● Change of conditions (s.127)

Delete conditions 4(i) and 4(j) as they relate to a previous wastewater design superseded by a latter approved land use consent for the site.

Pursuant to Section 127 of the Resource Management Act, the Applicant is seeking to vary Conditions 4(i) and 4(j) of RC 2200465 - RMACOM which enabled a four-lot subdivision from a boundary adjustment of four existing titles. Land use consent was sought for the private accessway as well as the required excavations. The application was assessed as a Non-Complying Activity within the Coastal Residential and General Coastal zones under the Operative District Plan (ODP). The application was limited notified and consequently went to a hearing with consent being approved on 11th November 2020.

Figure 1: RC 2200465 - RMACOM Approved Plans showing wastewater area within Lot 1 to service Lot 4.

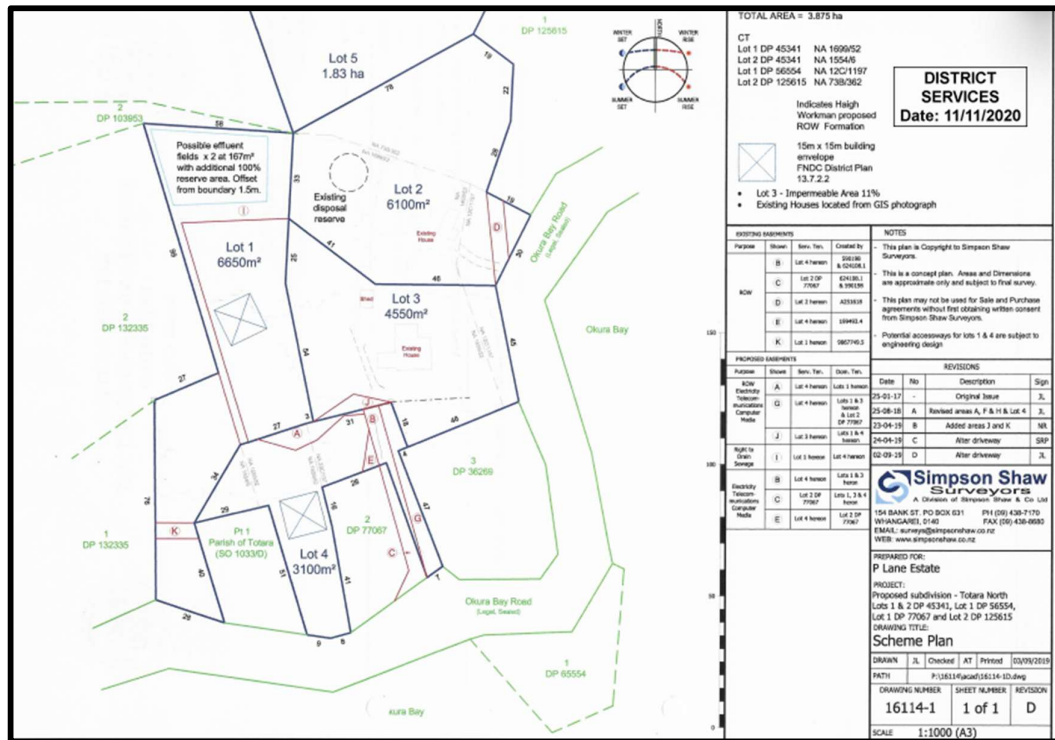
- 1.3. As part of RC2200465 – RMACOM, the onsite wastewater design for Lot 4 was recommended to be contained within the northern side of Lot 1, as it was determined that Lot 4 was too steep to contain an onsite wastewater system within its boundaries (see *Figures 1 & 2* below). As part of RC 2230445 – RMALUC, Haigh Workman determined that an onsite wastewater system could be designed within the southern portion of Lot 4 to service the proposed dwelling (see *Figure 3*), with the area set aside within Lot 1 being utilised as a reserve disposal area for Lot 4. Subsequently, the dwelling and associated onsite servicing have been constructed within Lot 4. An easement has been created over the reserve disposal area within Lot 1 to service Lot 4 as a backup reserve area for the approved and constructed onsite wastewater system within Lot 4. The approved onsite wastewater report prepared by Haigh Workman in support of RC 2230445 – RMALUC is contained within **Appendix 7** of this application.

Figure 2: Figure 1: RC 2200465 - RMACOM Approved Plans showing easement area within Lot 1 to service Lot 4.

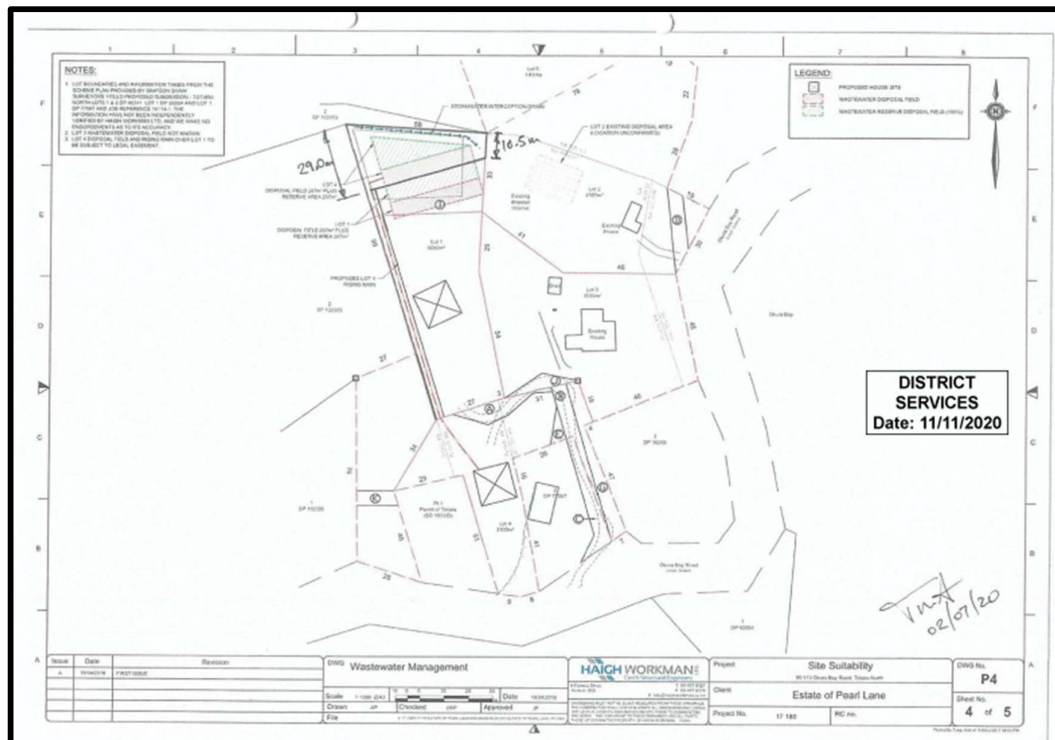
- 1.5. It is noted that the reserve area within Lot 1 to service Lot 4 is protected by an easement as well as an access easement down the western side of Lot 1, which are registered on the LT Plan. There is also a consent notice to be issued on the titles which reinforces this (see Condition (a)(iv) of RC 2200465). The reserve area is back-up only if the constructed onsite wastewater system fails within Lot 4 and as such, will only need to be accessed and utilised if the system ever fails. Conditions 4(i) and 4(j) of RC 2200465 – RMACOM were introduced to enable ease of access and use if they were to be used for the primary onsite wastewater system for Lot 4. As this is now not required, it is considered appropriate to delete these conditions. Access and use can still be granted if required, given these areas are protected by an easement, which also ensures that the areas set aside for reserve will not be built on or used for any other purposes which could adversely affect the use of the area for its intended use.

Figure 3: RC 2230445 - RMALUC Approved plans showing onsite wastewater system within southern side of Lot 4.

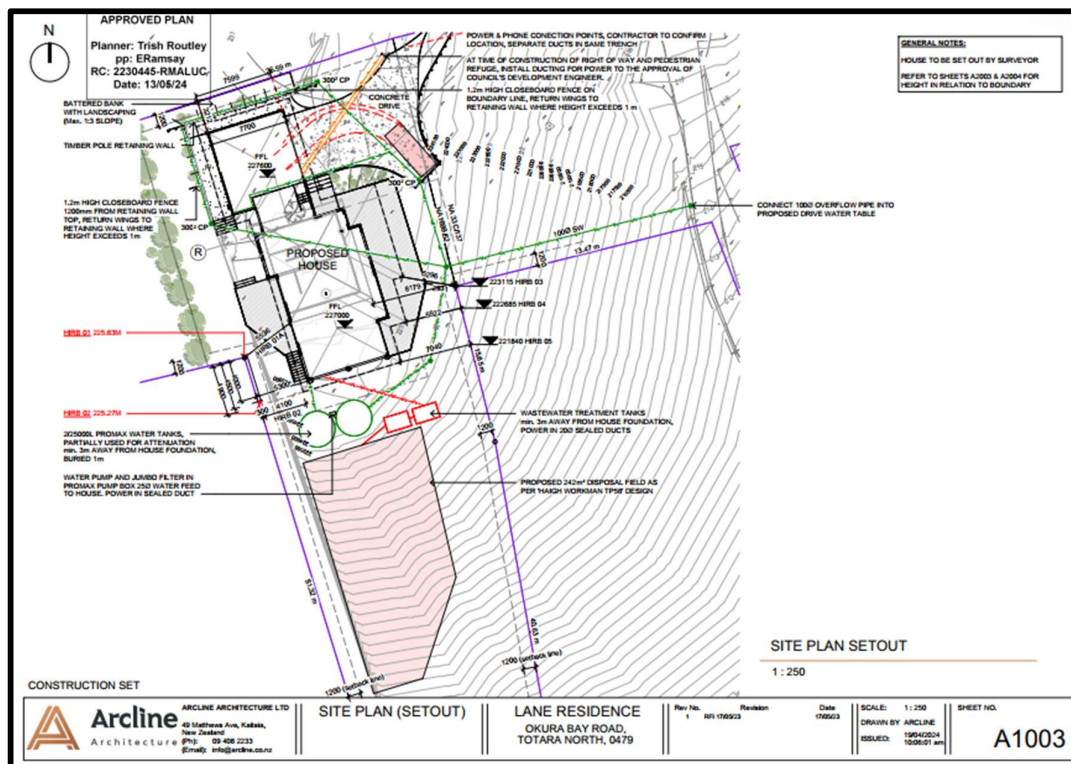
- 1.4. The Applicant is currently preparing the documents required for the s224(c) certificate of RC 2200465 – RMACOM and Conditions 4(i) and 4(j) reflect the previous onsite wastewater design for Lot 4 which are now considered to be redundant given the approved wastewater design under RC 2230445 – RMALUC. As such, the Applicant is requesting to have these conditions deleted in their entirety to align with the approved design under RC 2230445 – RMALUC.
